Amendment to Precinct One Approval - Amended to reflect revised road and internal boundaries.

PLAN OF DEVELOPMENT
SUPERBLOCK A - MIXED USE EMPLOYMENT FOCUSED

Dgn No. YB-P01-NRPOD101118K SHEET 3A OF 9

PLANS AND DOCUMENTS
referred to in the PDA APPROVAL

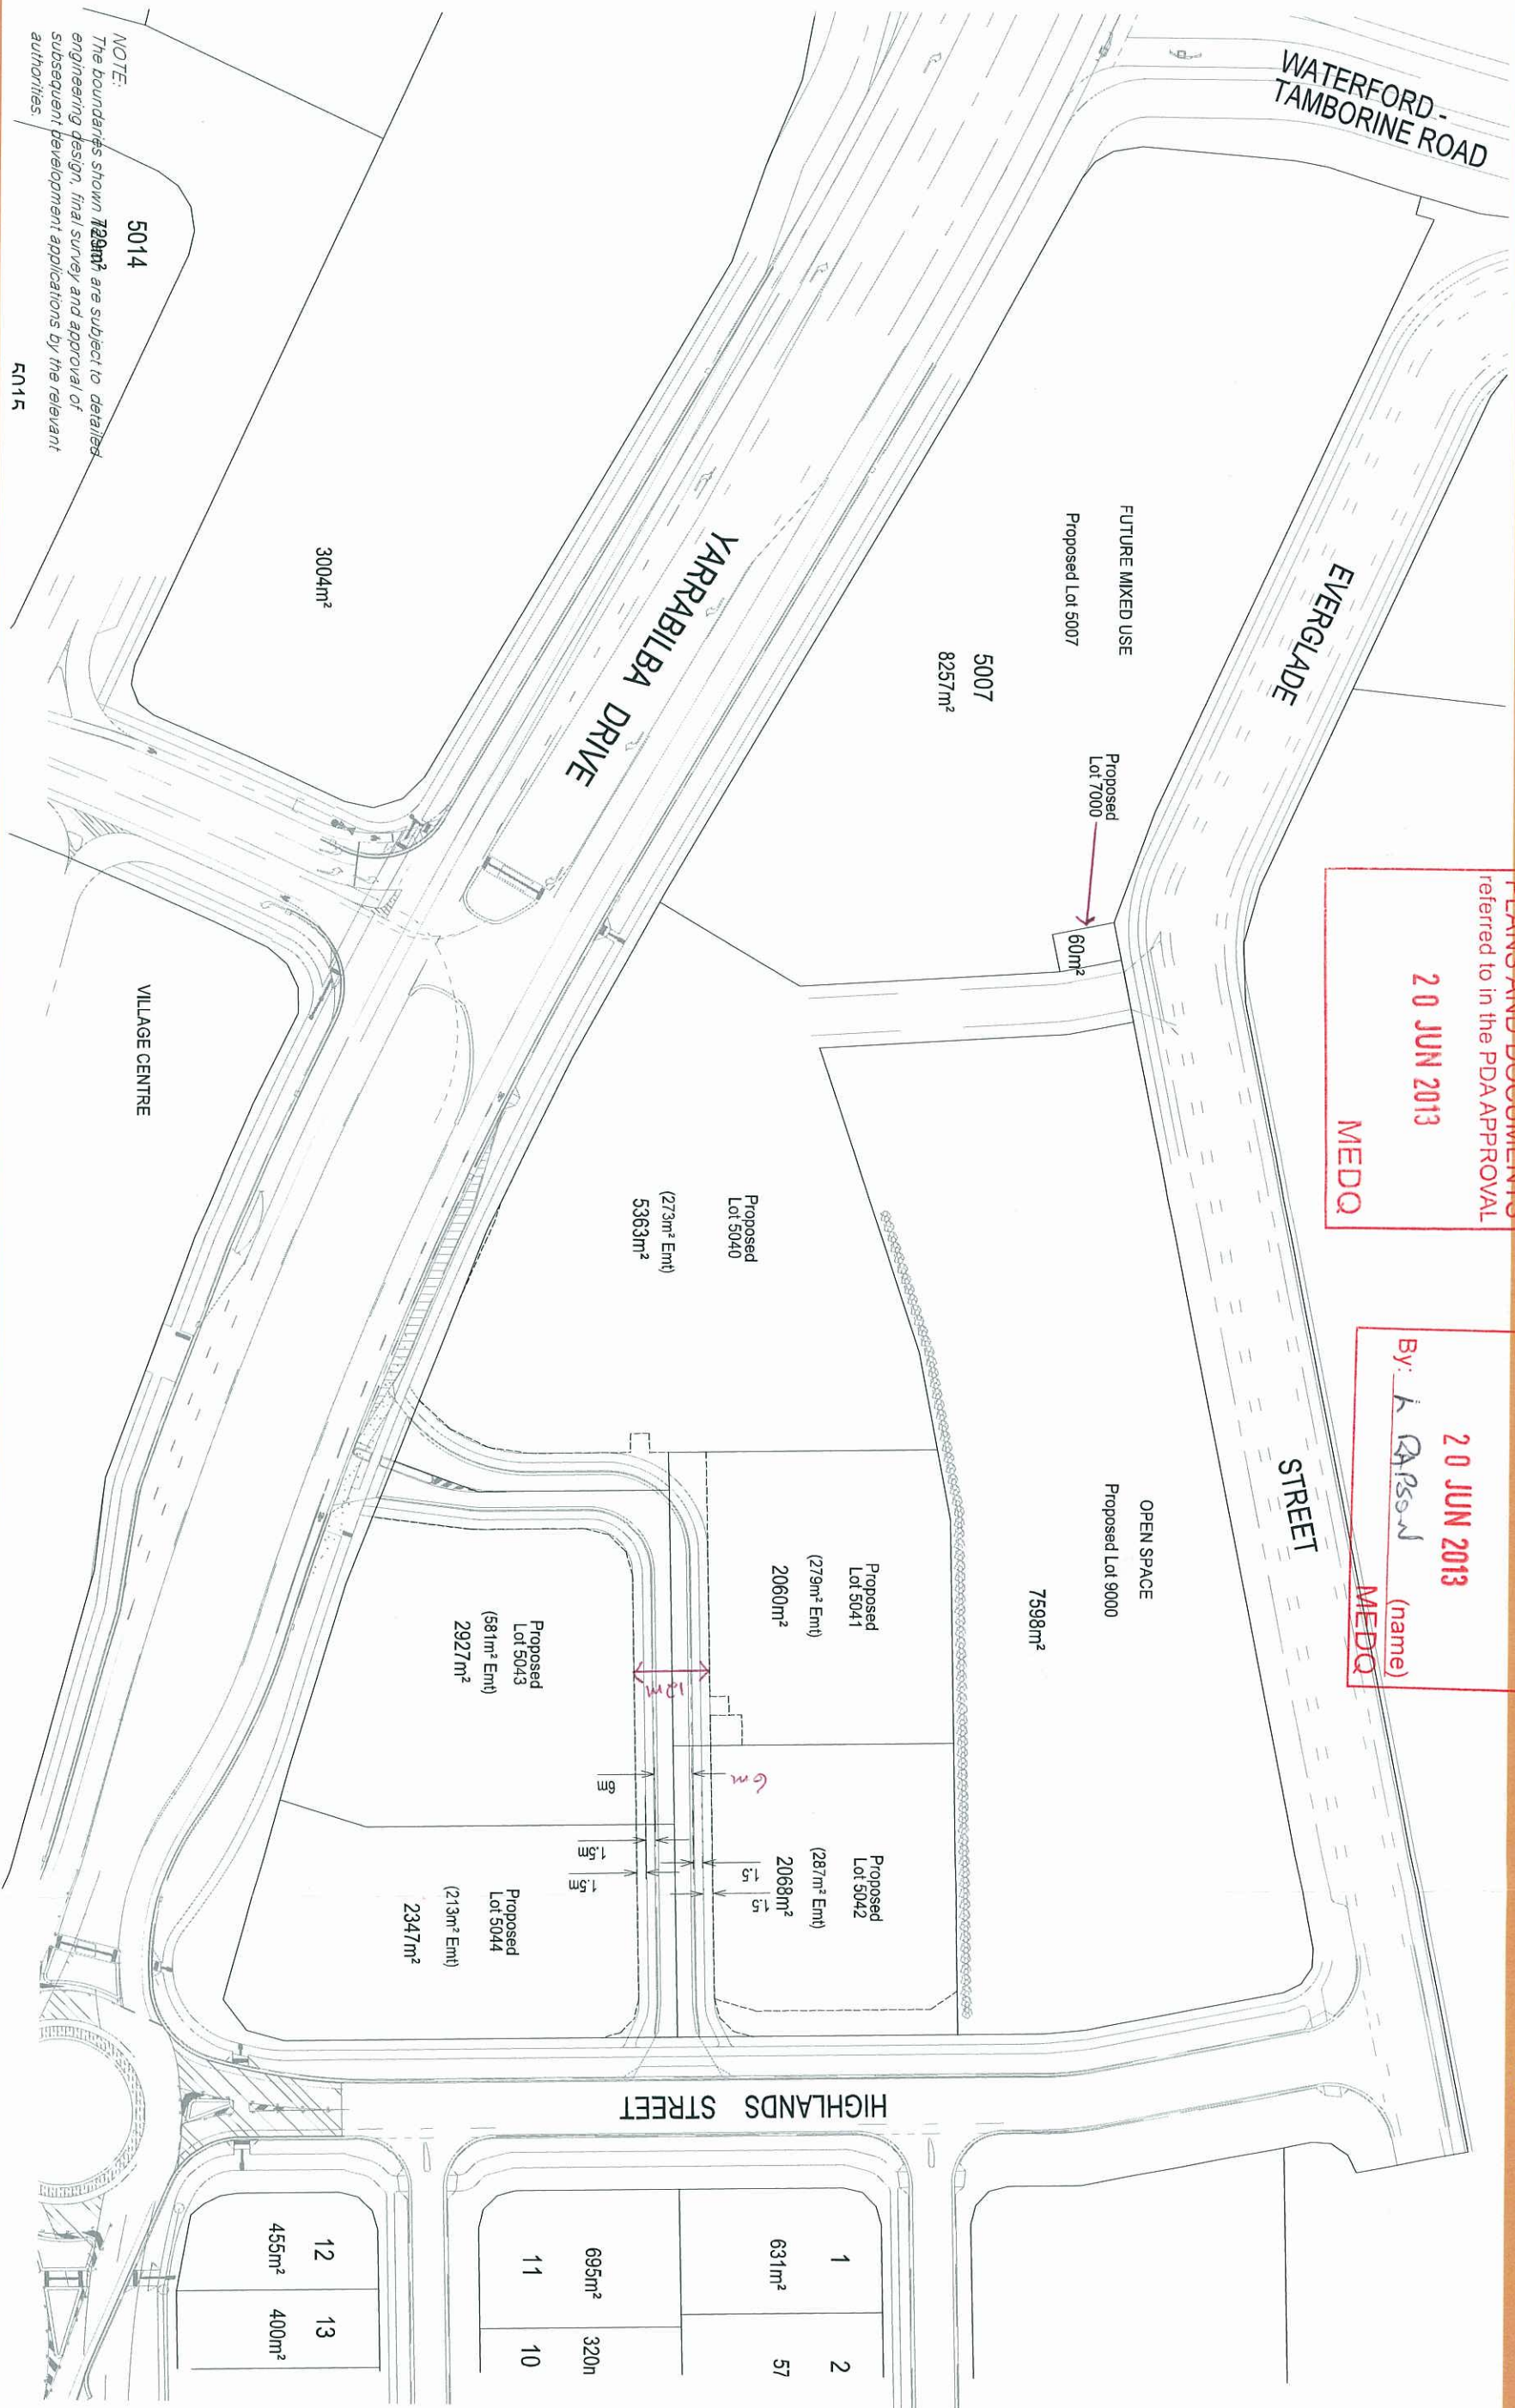
AMENDED IN RED

RECONFIGURATION OF A LOT - AMENDMENTS

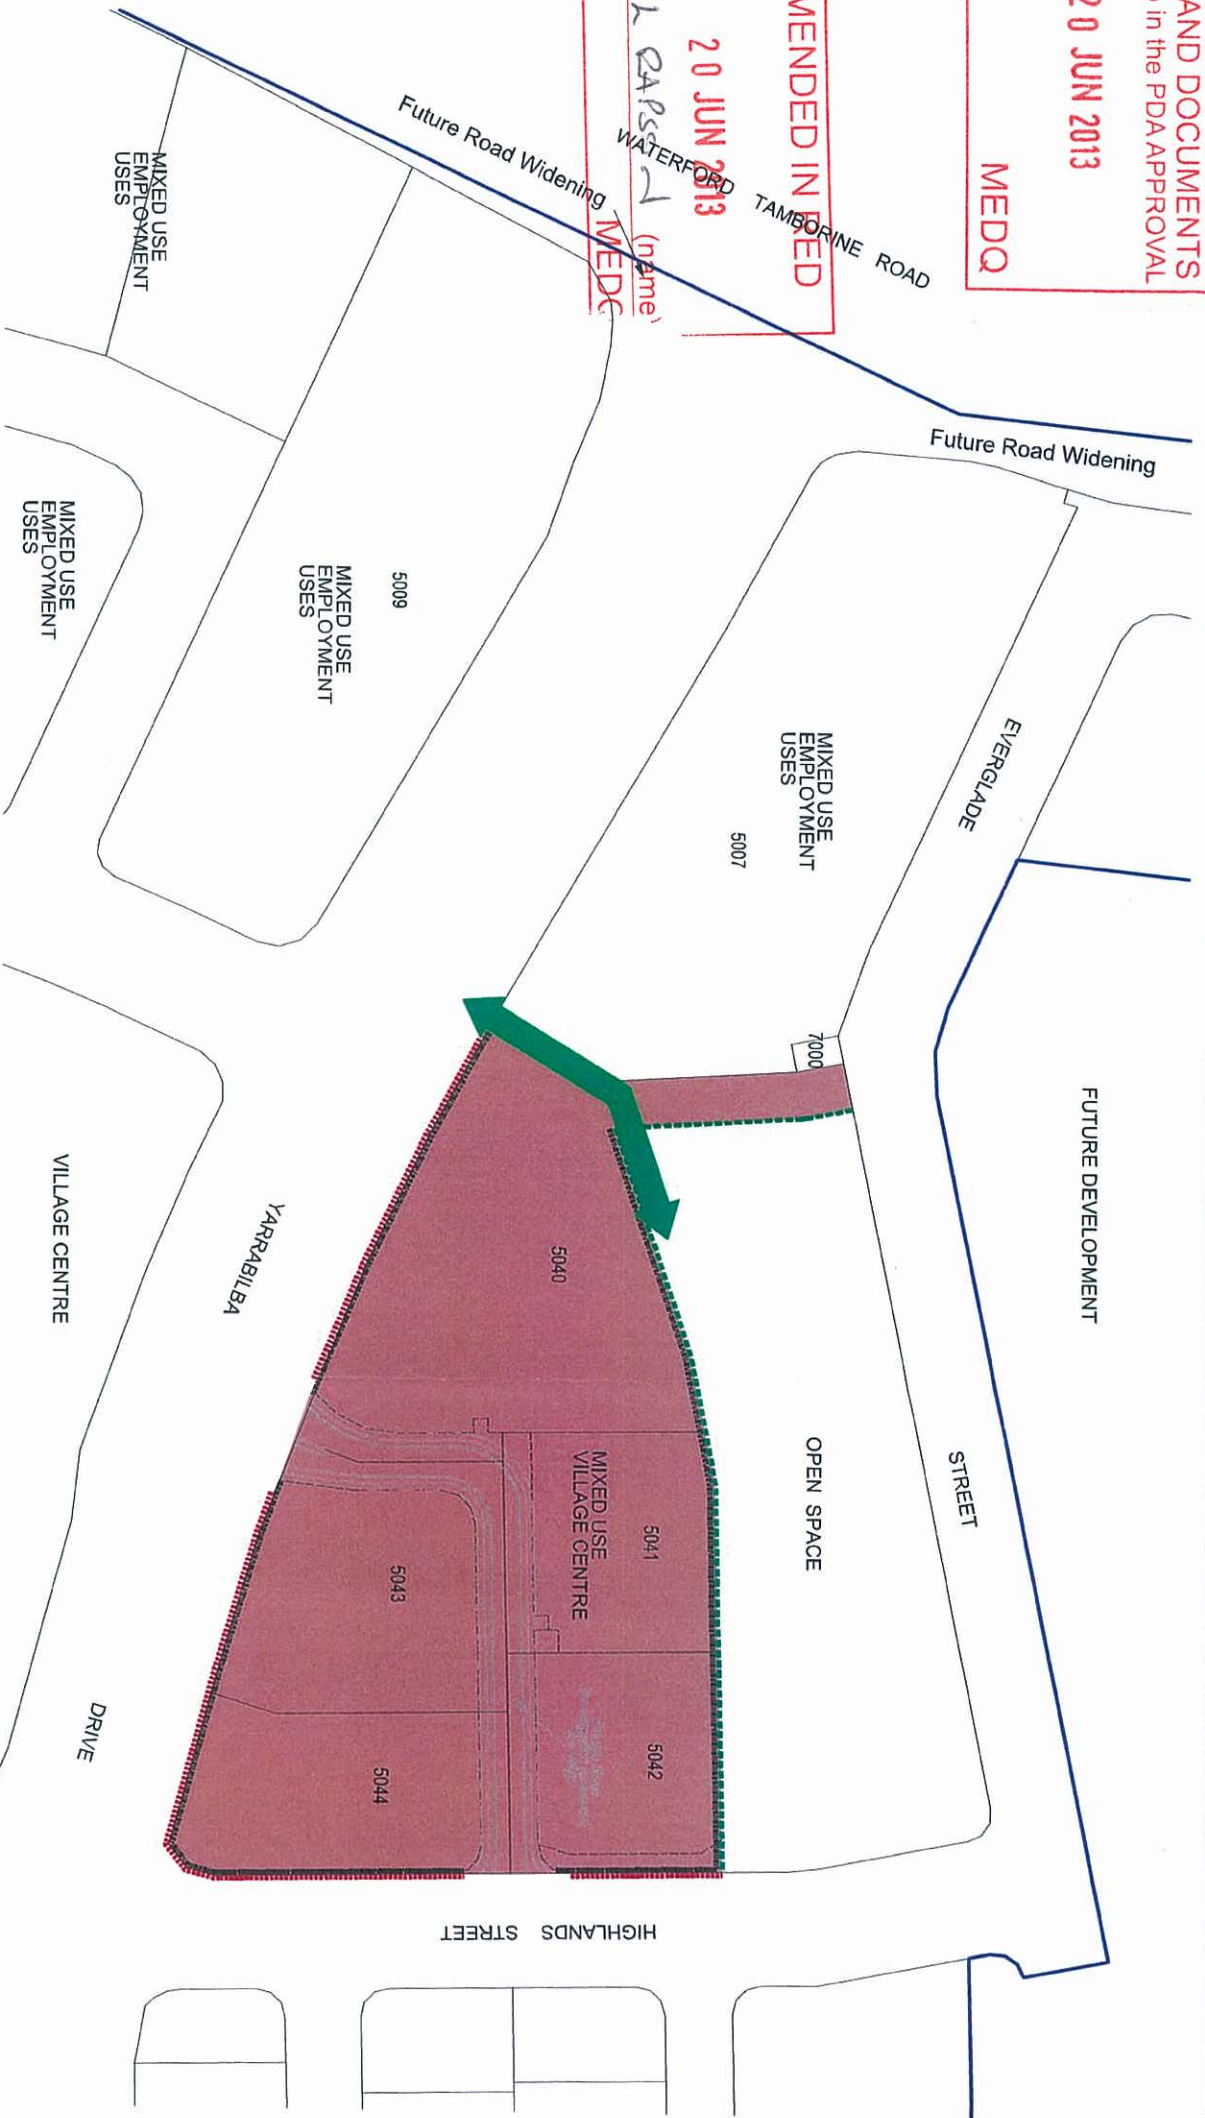
1. GENERAL LOT TYPE AMENDMENTS AND INTERNAL BOUNDARY REALIGNMENTS.
2. EDUCATION SITE RESUBDIVISION.
3. ~~SUPERTBLOCK~~ A RESUBDIVISION
